Flood Assessment Addendum

**Burrah Park, 1953-2109 Elizabeth Drive,
Badgerys Creek**

June 2025

30206389-EF002-01-Flood
Assessment

Figure 1 Development Layout

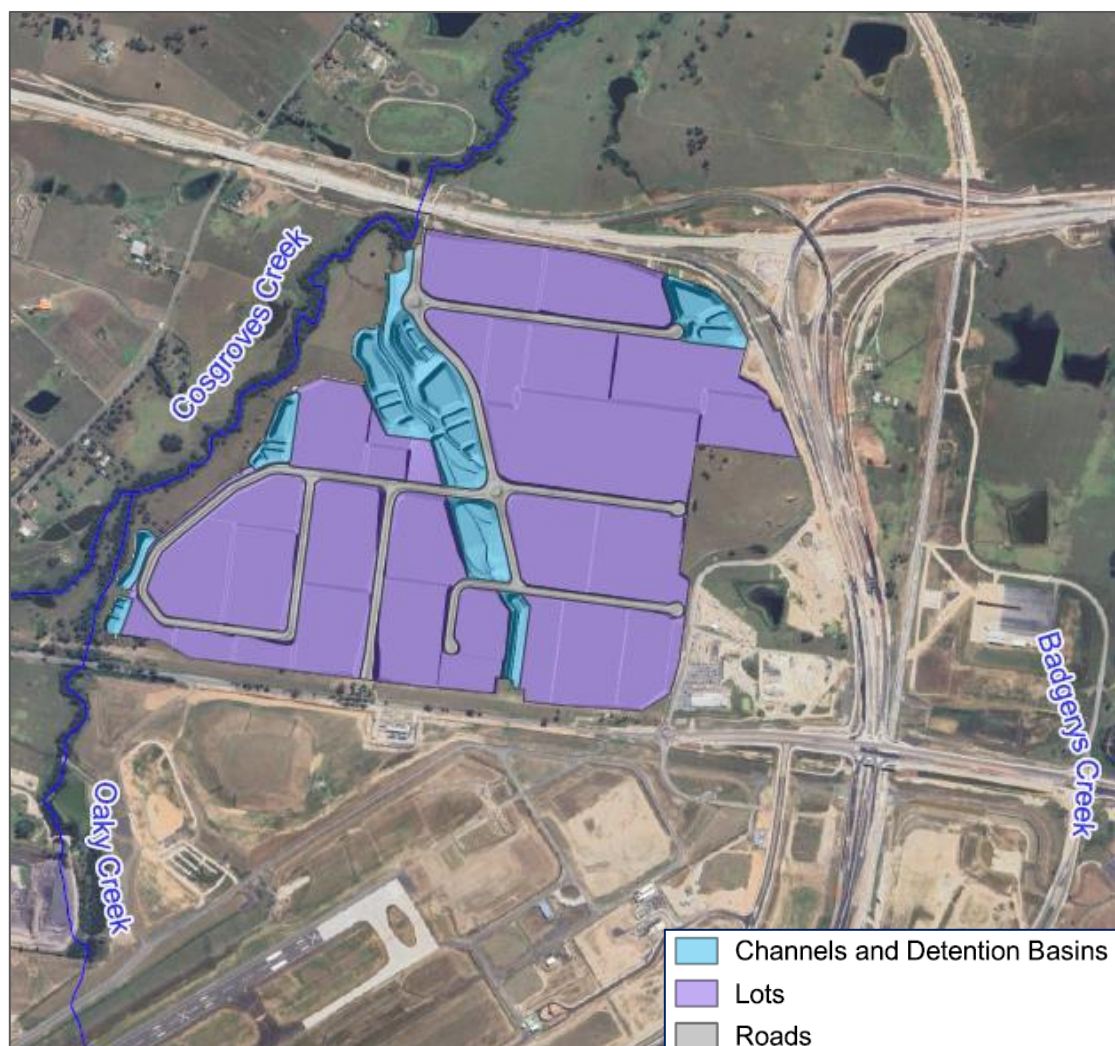
Following receipt of a revised design surface (TIN) on 13 May 2025, which incorporated updated lot layouts, internal roads, drainage channels, and detention basin locations, the flood modelling for the developed scenario was re-run to reflect these changes (refer to Figure 1). The changes most relevant to the flood assessment include the detention basin located adjacent to the Cosgroves Creek flow path and adjustments to the development footprint in the north-west corner of the site, near the M12 Motorway. The updated TUFLOW model incorporated the revised design surface overlaid onto the existing terrain, ensuring that all developed-case results were based on the most current development layout.

Figure 2 Flood Impacts: 1% AEP Flood Level Design vs. Existing (Cosgroves Creek)

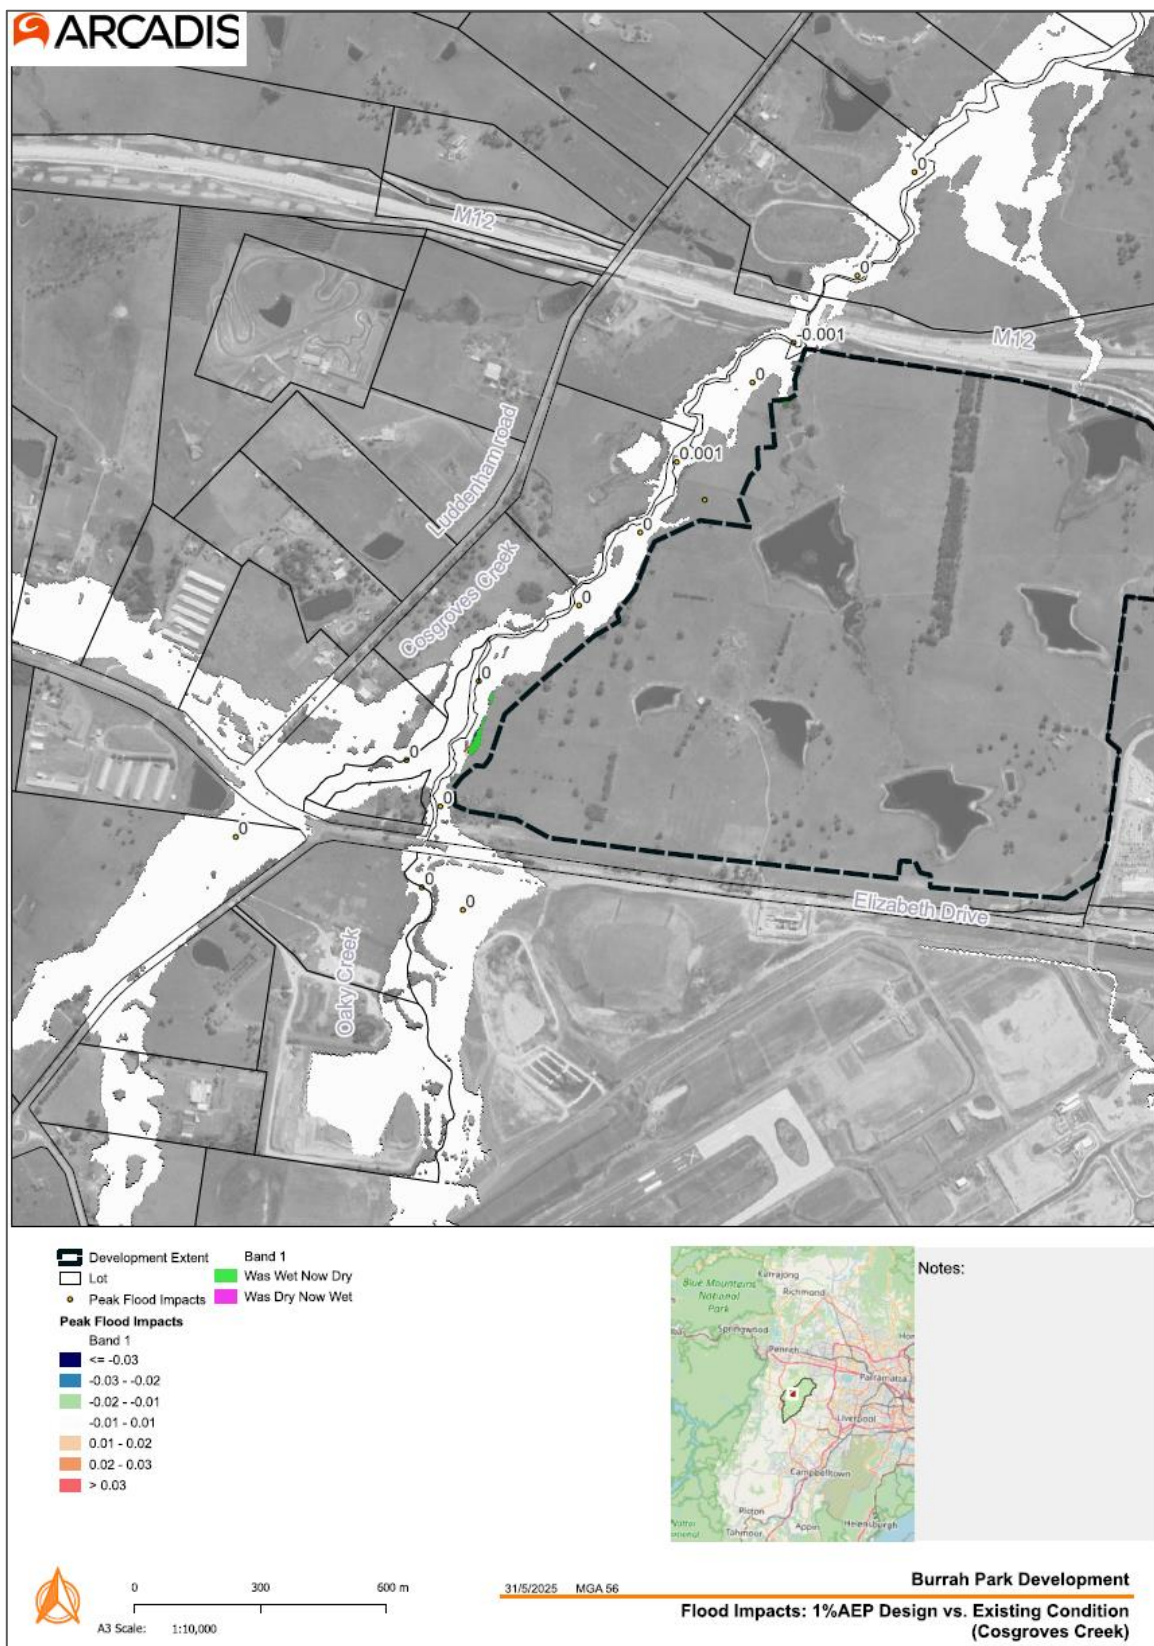
- For the 1% AEP event, flood level increases are minimal, with localised rises of a few millimetres near the site boundary. These increases are attributed to slight encroachment into the existing Cosgroves Creek floodplain (see Figure 2).
- For the PMF event, the impacts of development are more pronounced (see Figure 3). Observed effects include:
 - Peak flood level increases of 15 to 50 mm, with the greatest changes occurring upstream of the M12 and some minor impacts on properties west of Cosgroves Creek.
 - No change in flood hazard categories across most areas, with only small localised zones seeing a one-category increase.
 - The M12 Motorway is not expected to be overtopped, with flood levels remaining below the road surface. However, this assessment is subject to confirmation based on future detailed design information for the M12.

Figure 3 Flood Impacts: PMF Flood Level Design vs. Existing (Cosgroves Creek)

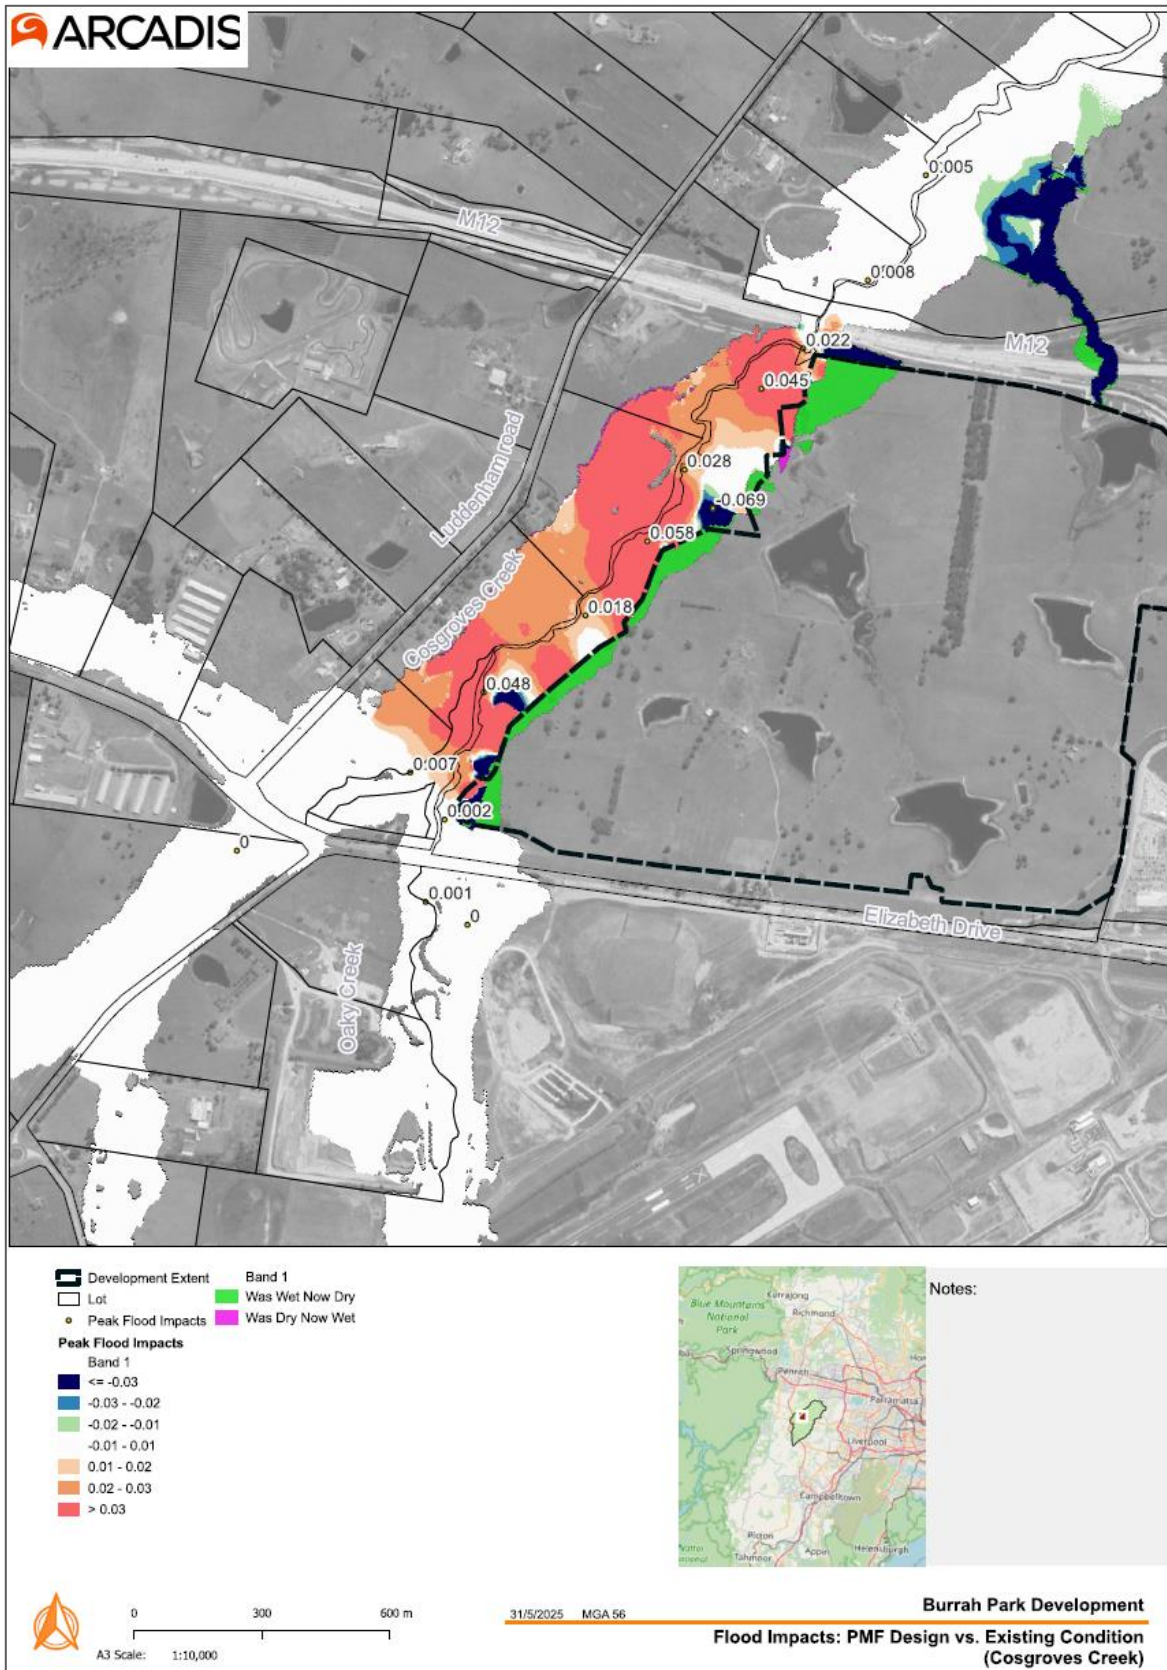
Overall, PMF impacts are considered minor and are not expected to result in adverse effects on surrounding properties or public infrastructure.

Figure 4 Flood Impacts: 1% AEP Climate Change Flood Level Design vs. Existing (Cosgroves Creek)

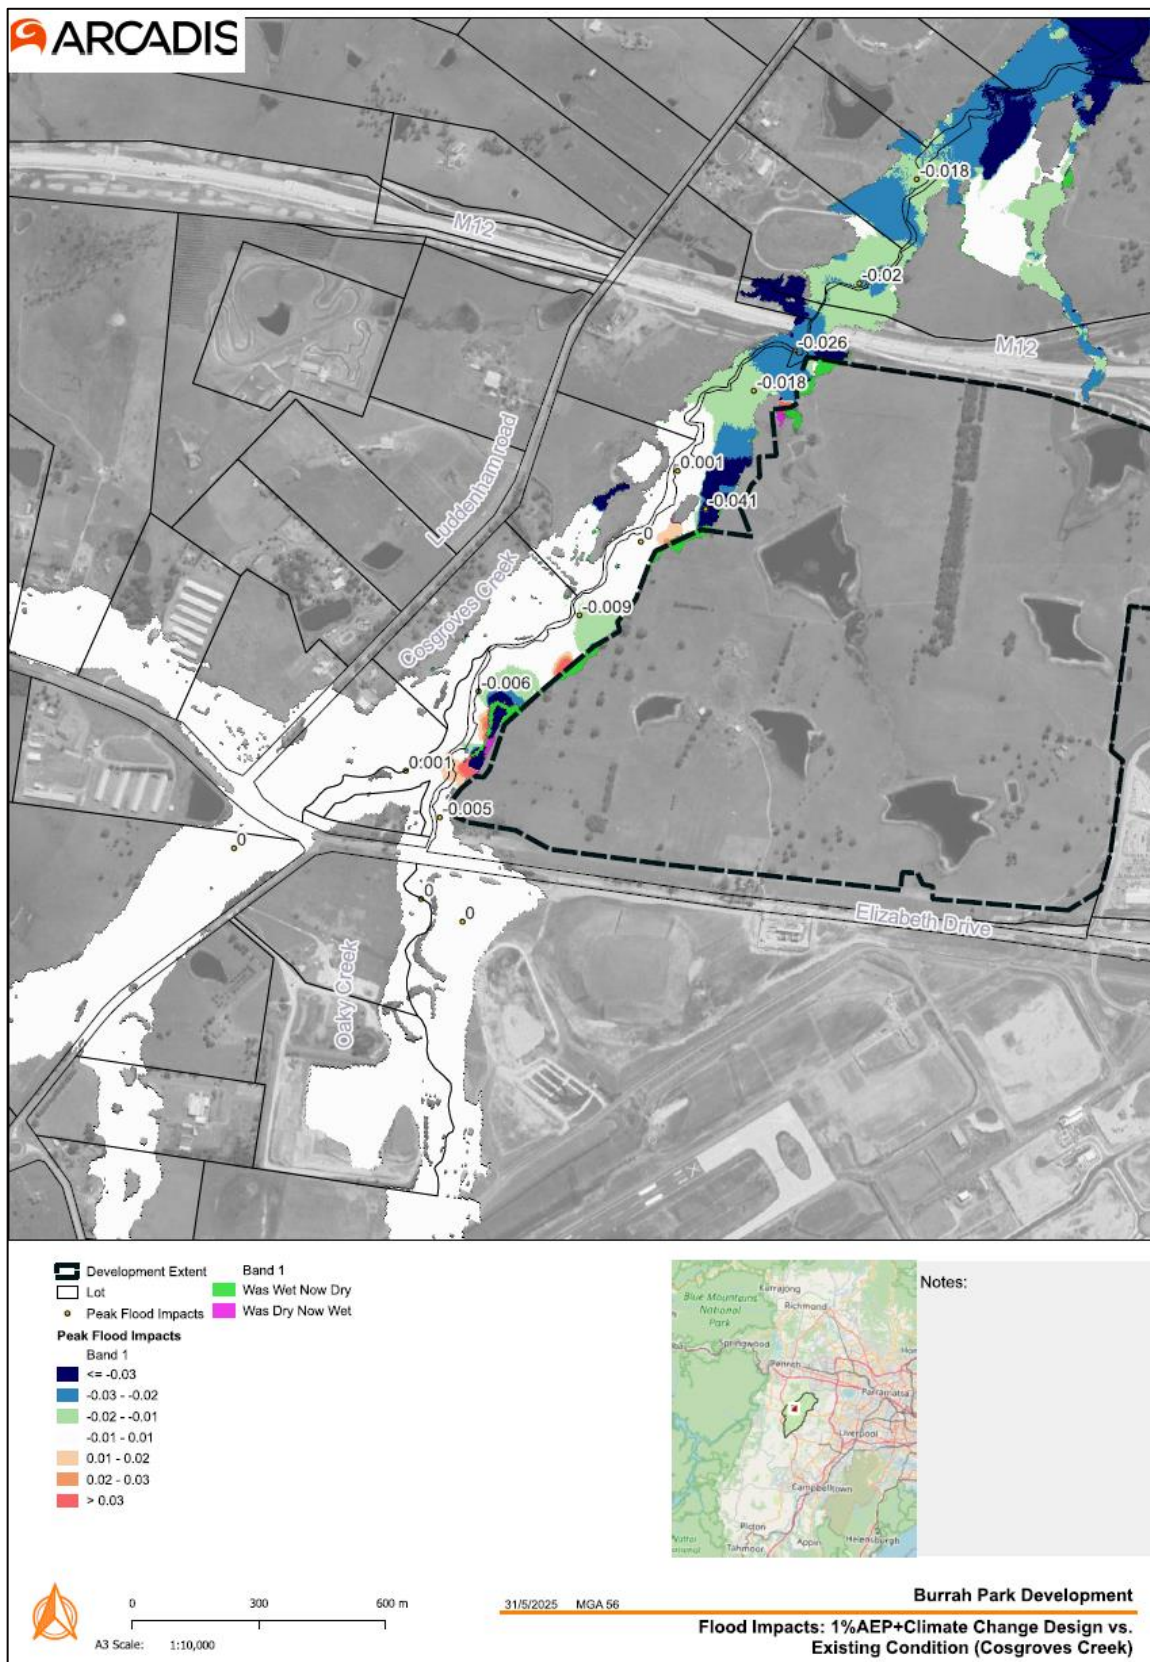
- Peak flood levels in Cosgroves Creek slightly decrease under the climate change scenario. This is attributed to the earlier timing of peak discharges from the developed catchment, resulting in reduced coincidence with downstream peak flows.
- Minor localised increases in flood levels are observed adjacent to the southern detention basin and areas where the proposed development encroaches slightly into the existing floodplain (Figure 4). These increases do not extend across the creek and are not considered significant.

2.3 PMF flood Storage Analysis
